PROJECT: DCSD 2021 CIP - Parker Package **CONTRACTOR:** Mark Young Construction
DATE: July 23, 2021 **CHANGE ORDER #:** 14

Subject: **Change Order Request #21 – CCD #7 Structural Steel Revisions**

CONSTRUCTION CHANGE DIRECTIVE

PROJECT: Pine Lane Elementary School - North
Douglas County School District 2021 CIP Projects

GIRDER TRUSS LINE B AND C LOOKING NORTH
1/4" = 1'-0"

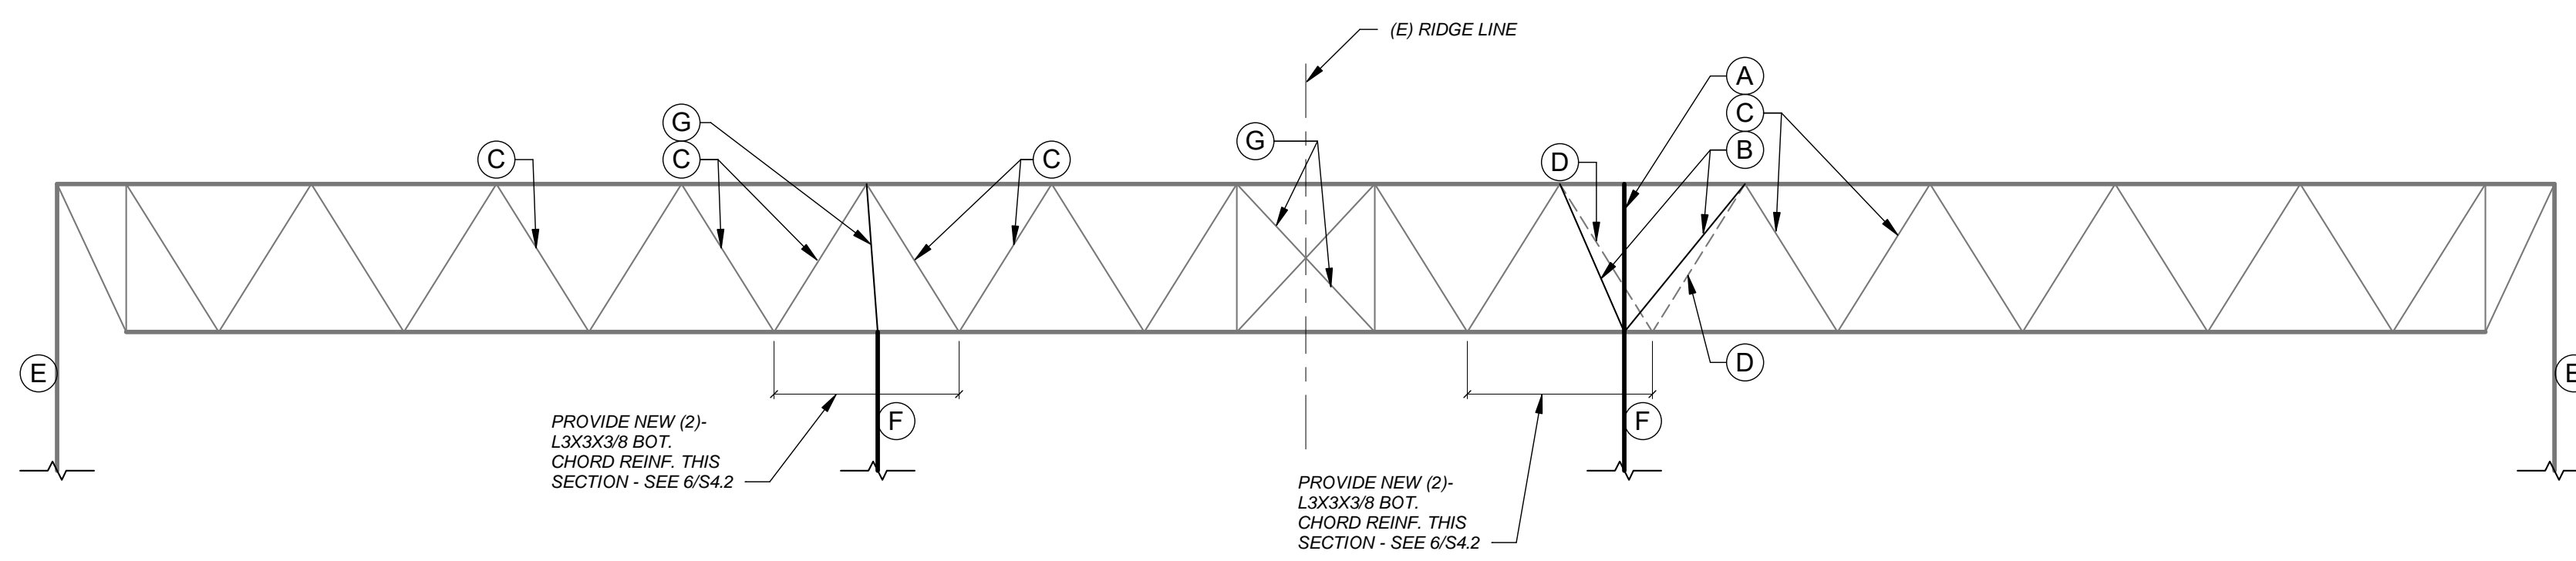
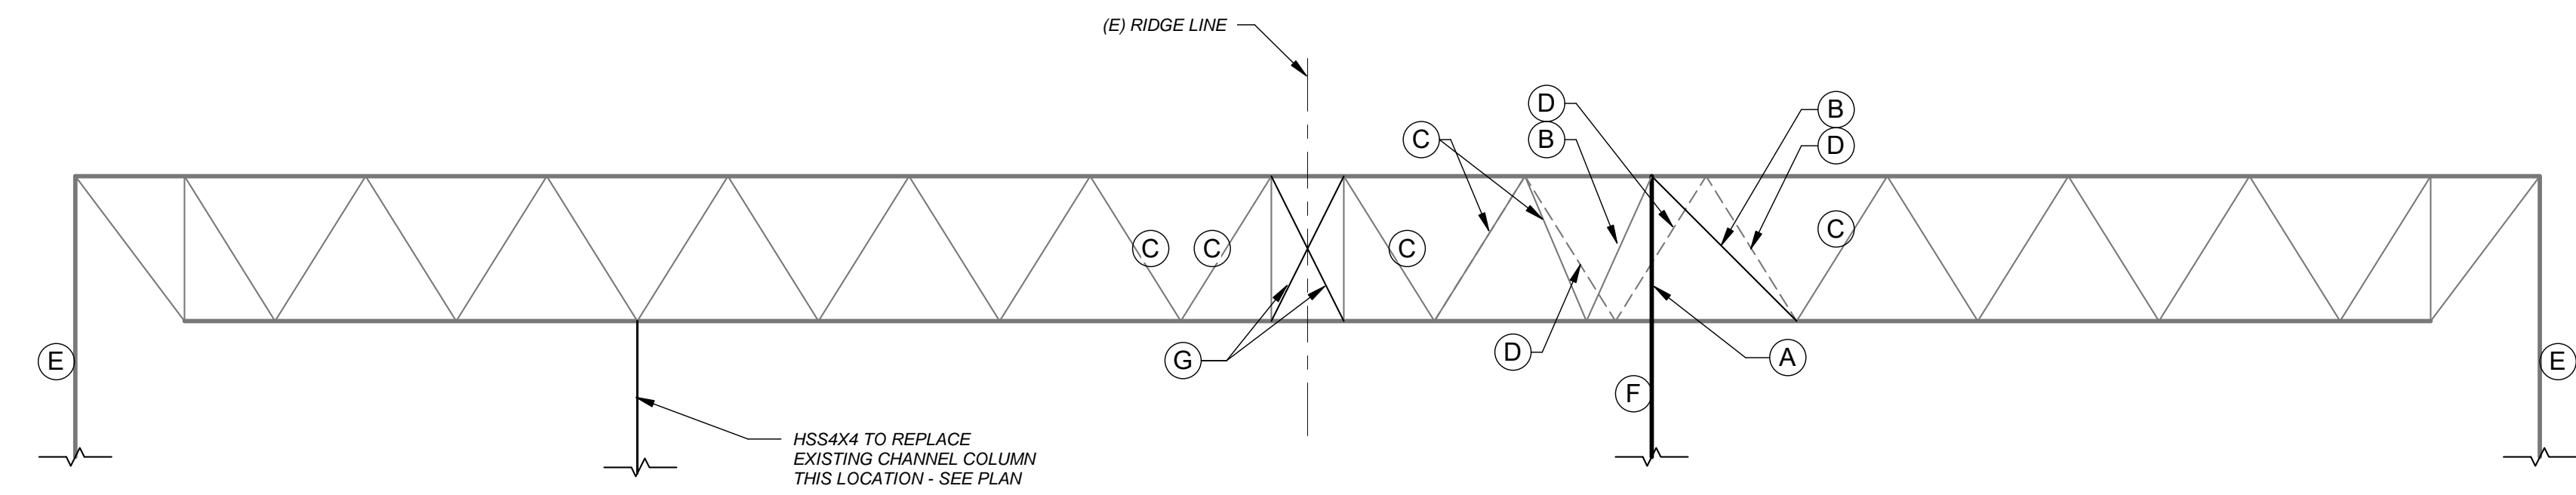
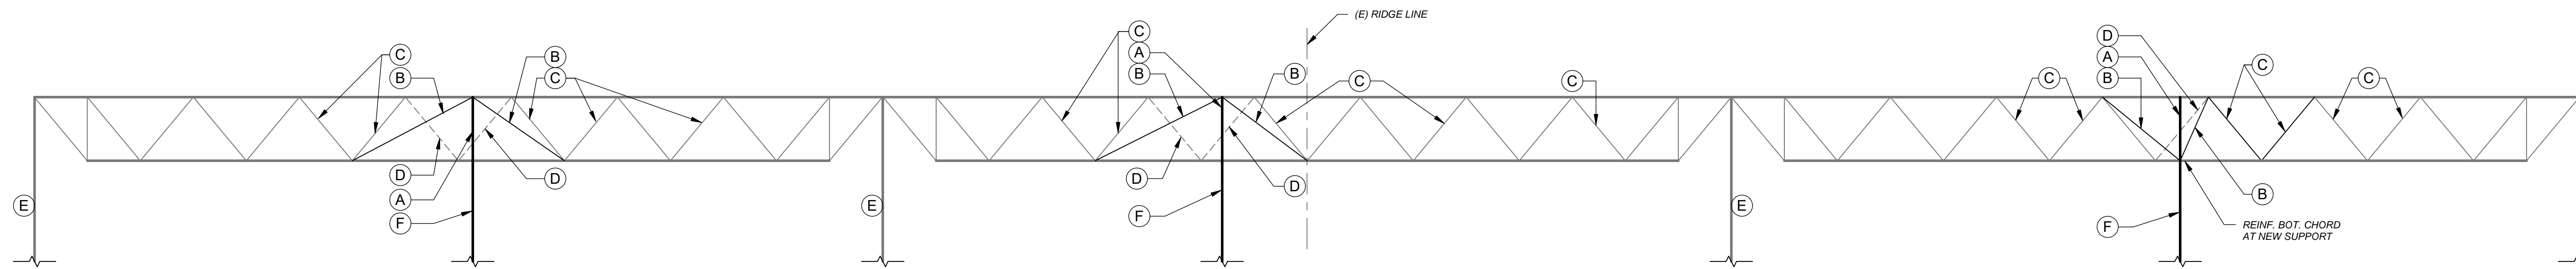
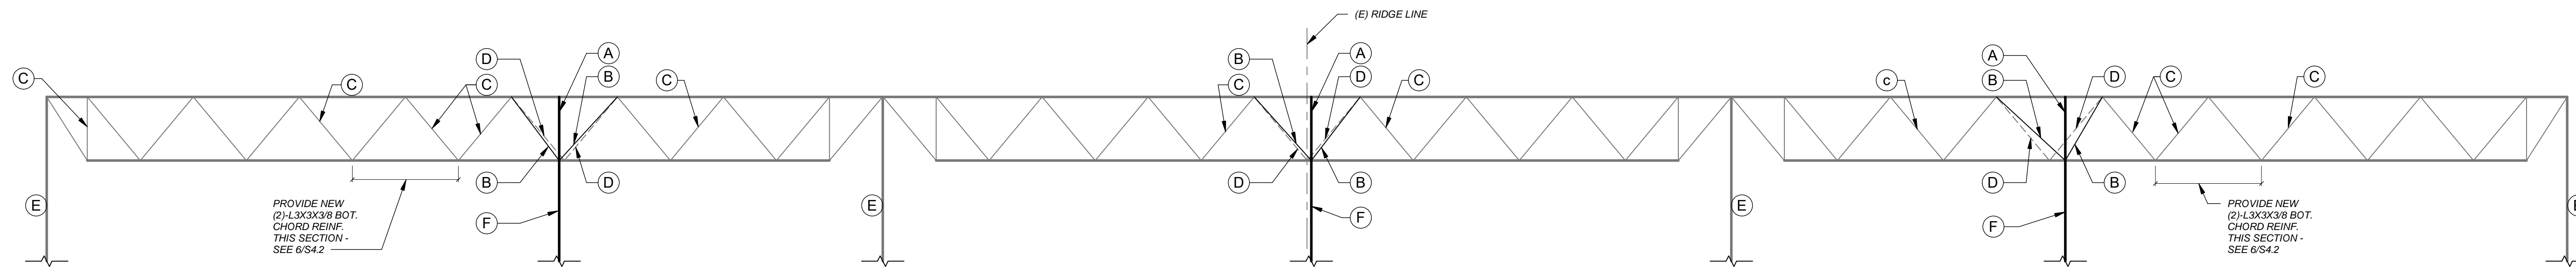
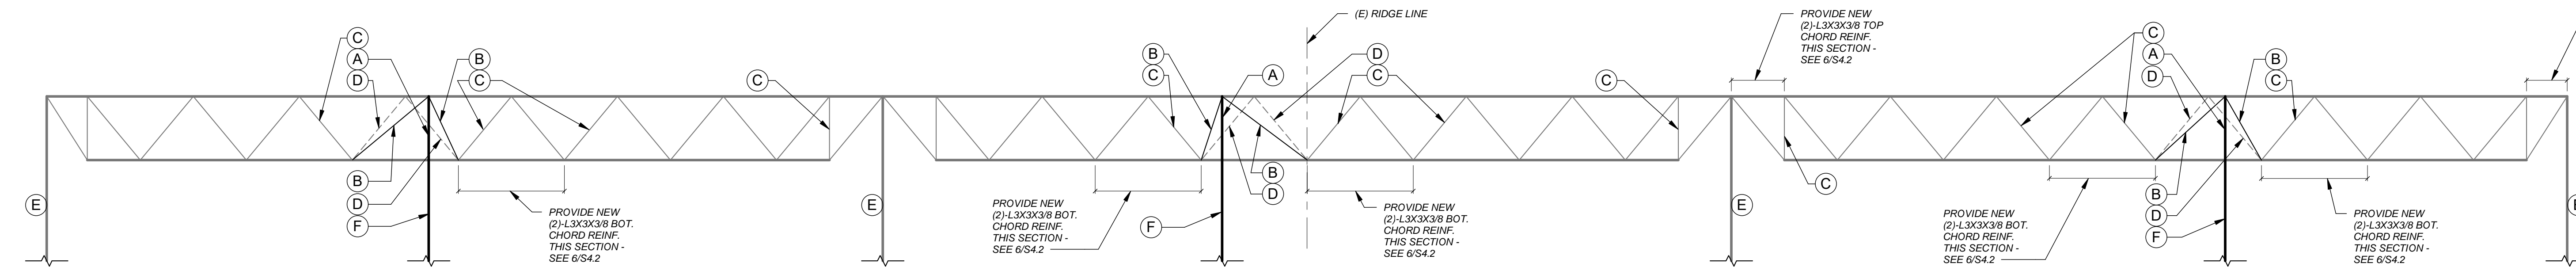
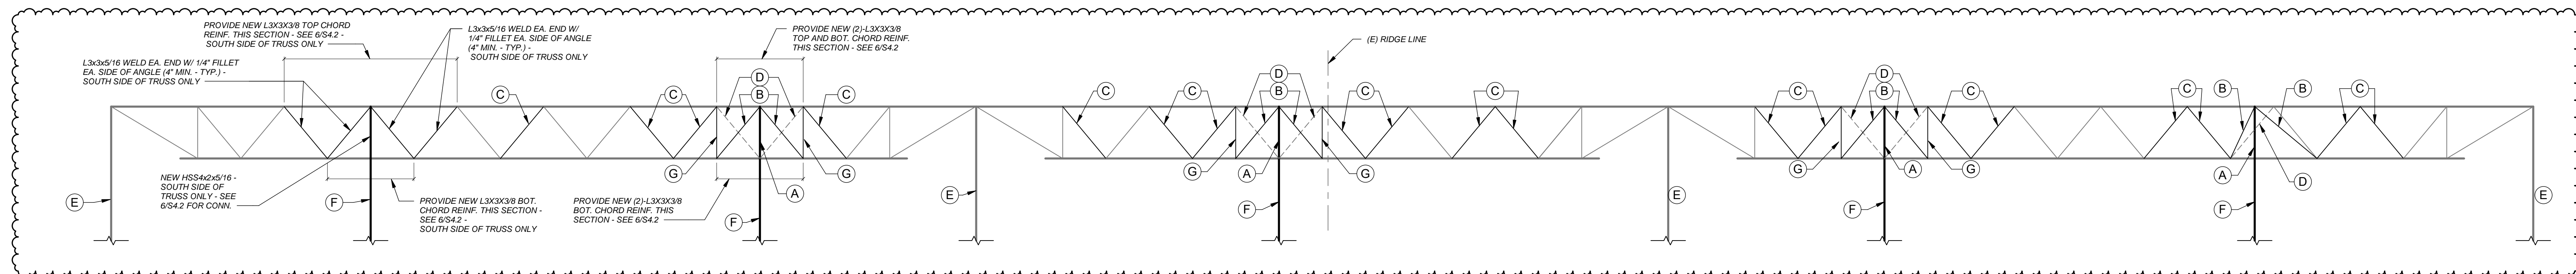
- A. Add new HSS4x2x5/16 and new web plate. See detail 6/S4.2.
- B. Replace existing web angles with new L2 1/2x2 1/2x3/8. See detail 8/S4.2. Do one side at a time, one member at a time. Add vertical L2 1/2xwhere shown.
- C. Sister existing web angles with new L2 1/2x2 1/2x1/4. See detail 8/S4.2.
- D. Web member to be removed.
- E. Existing column to remain.
- F. New column. See plan for size.
- G. Add 2 new L2 1/2x2 1/2x3/8 diagonal web member.
